# Historical Architectural Review Board COA Preliminary Review Sheet

**HDC-2024-00096**

**Address: 523.5 N 6<sup>th</sup> Street**

**Proposal: Front façade alterations**

**Front Elevation (Google Imagery, 2023)**

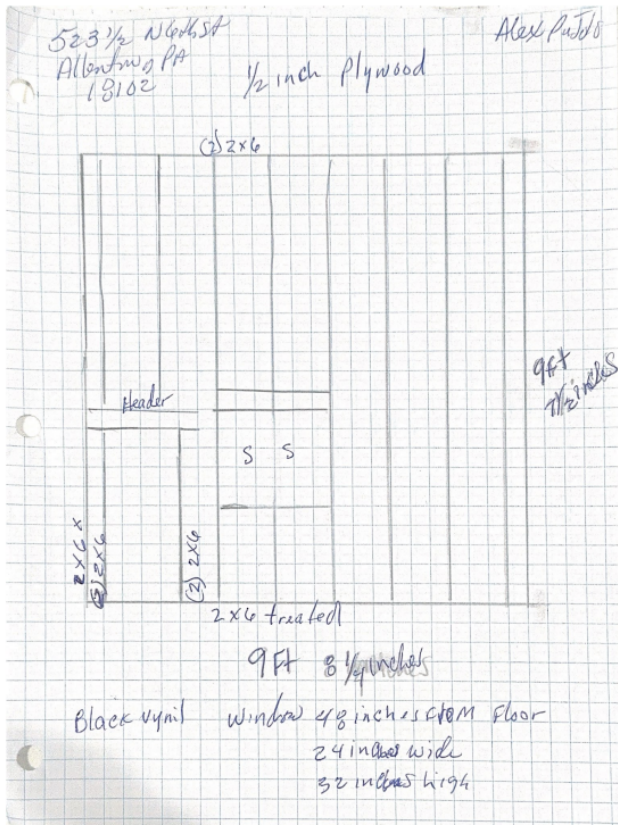
523 ½ North 6<sup>th</sup> Street is an extant example of commercial architecture in a residential neighborhood, with much of its historic integrity and character defining features intact. The façade elements include a recessed entry, large panes of storefront glass with an upper register of small square panes, which are painted over. The original wood storefront cornice exists above the storefront itself, and decorative building cornice aligns with the porch cornice at 525 N. 6<sup>th</sup> Street, matching in detailing and scale.

Guidelines Section 3.13-Commercial Storefronts calls for the preservation of existing features of historic ground floor storefronts and primary facades. Although the historic districts are primarily residential, scattered commercial storefronts were historically incorporated in the ground floor of buildings, and add a dynamic element to the streetscape. Additional information, such as evidence for the need to remove the storefront, was not provided.

**Proposed Construction (Applicant)**

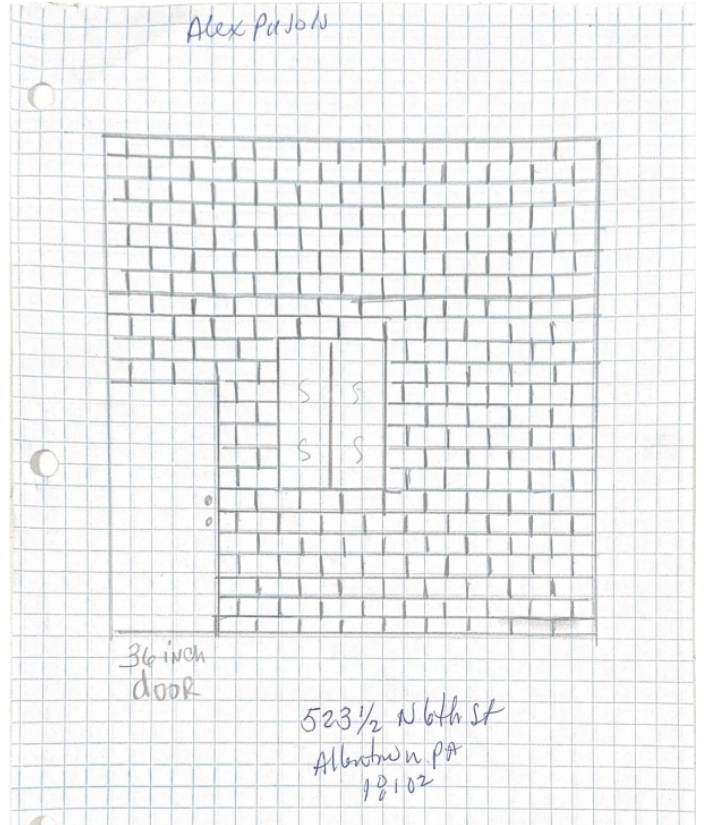
The proposed work calls for the removal of this original storefront and storefront cornice, and for the construction of a solid brick wall with a 36” wide door and a single 24”W x 32”H black vinyl window with a 48” sill height. Further detail that would help in evaluating the proposed work includes: the configuration and material of the proposed door, the configuration and function of the window, the type, size, and color of the proposed brick.

The proposed façade alterations remove the character defining features of this primary façade, which is not appropriate per the Guidelines. Additionally, the proposed window is not appropriate in materiality, dimension, and location, and the overall design of the proposed alterations do not draw from the form, massing, and proportion of the existing configuration.

**Staff Recommendation:** Staff recommended to deny the application.

**Actions:** Mr. Jordan moved to deny the application presented on November 4, 2024, for front façade alteration at 523 ½ North 6<sup>th</sup> Street as submitted, finding noncompliance with Guidelines for Historic Districts: Chapter 3, Section 3.5 – Windows, Section 3.6 Doors, and Section 3.13 Commercial Storefronts, and found no circumstances unique to the property.
